Subject: Permit modification request for the proposed improvements to US 17 in Onslow, Jones and Craven Counties, TIP No. R-2514B, C & D. Debit \$570 and \$100 from WBS 34442.1.3.

As you are aware, the North Carolina Department of Transportation (NCDOT) is constructing improvements to US 17 from SR 1330/SR 1439 south of Belgrade to the New Bern Bypass. Permits for this project were issued in 2015, and the project was let to construction on June 16, 2015. The NCDOT is requesting a permit modification to allow for changes the contractor wants to make to the work trestle at permit Site 4 on section R-2514D (structures 7 & 8D at Sta. 389+47.50-L- on the highway plan sheets).

STATE OF NORTH CAROLINA DEPARTMENT OF TRANSPORTATION RALES01H GENERAL DRAWING BRIDGE OVER TRENT RIVER ON US17 BETWEEN SR 1337 & SR 1121 LEFT LANE			
REVISIONS NO. BY DATE NO. BY DATE 1 1 3/13/2015 2 4 3/13/2015			
SHEET NO. S07-2 TOTAL SHEETS 68			Baker Michael Baker Engineering 8000 Regency Parkway, Suite 200 Cary, North Carolina 27518 NC License No.: P-1094

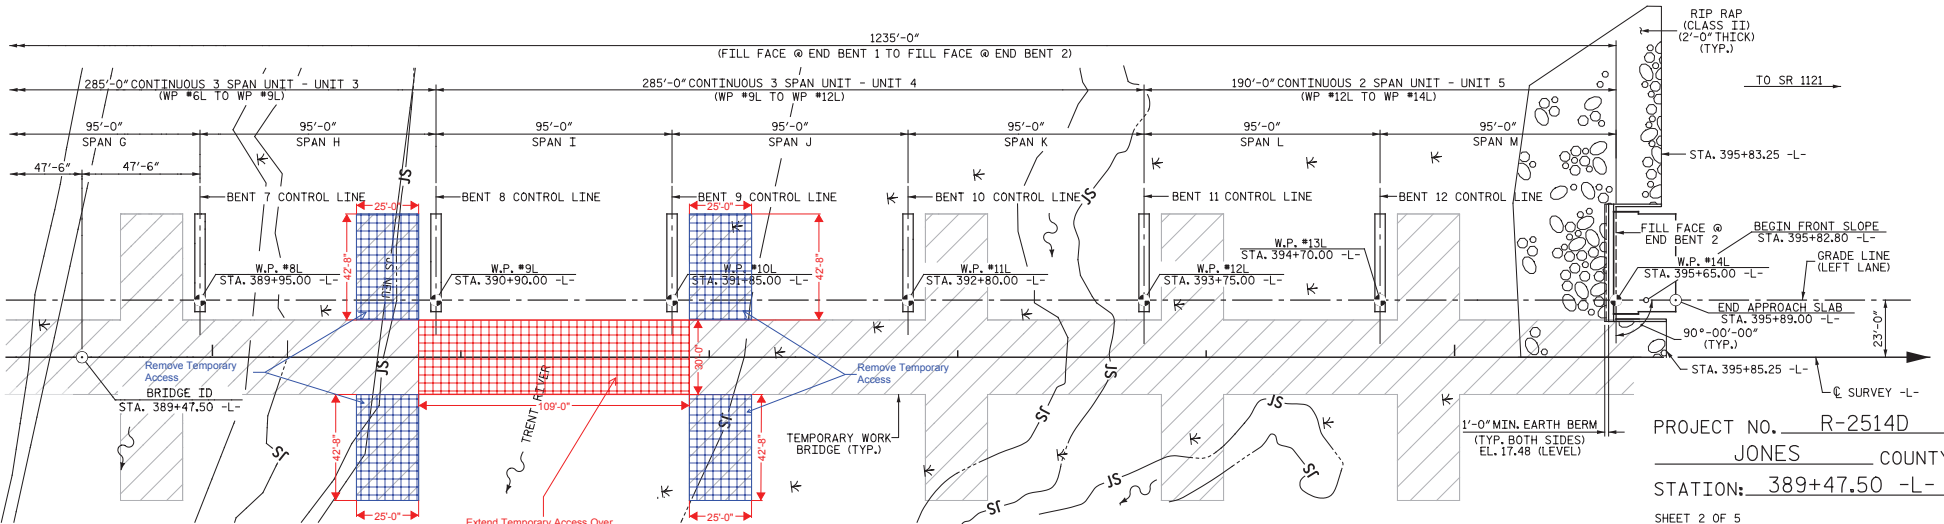
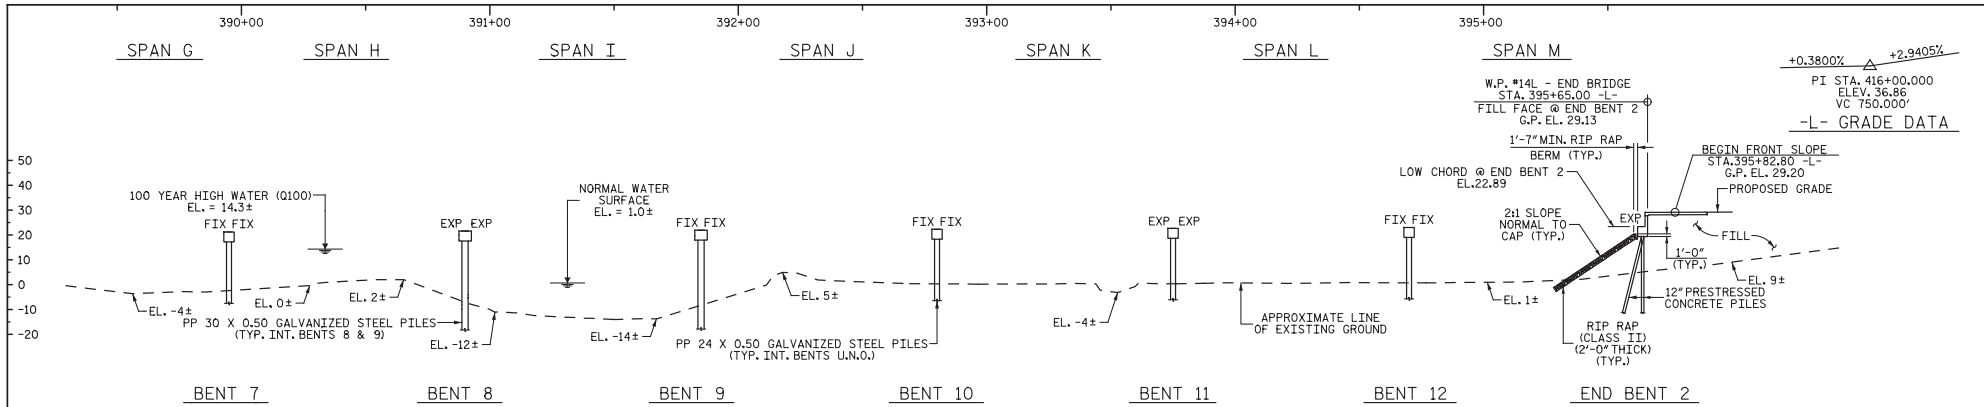
The modified design will remove two fingers at bents 8 and 9 of the permanent bridge and extend the work trestle over Trent River connecting the two sides. The additional area requested will have a trestle with a maximum width of 30 ft and a minimum low steel elevation as the proposed permanent bridge and the existing US 17 bridge located downstream. Please see the attached plan sheet showing the proposed changes.
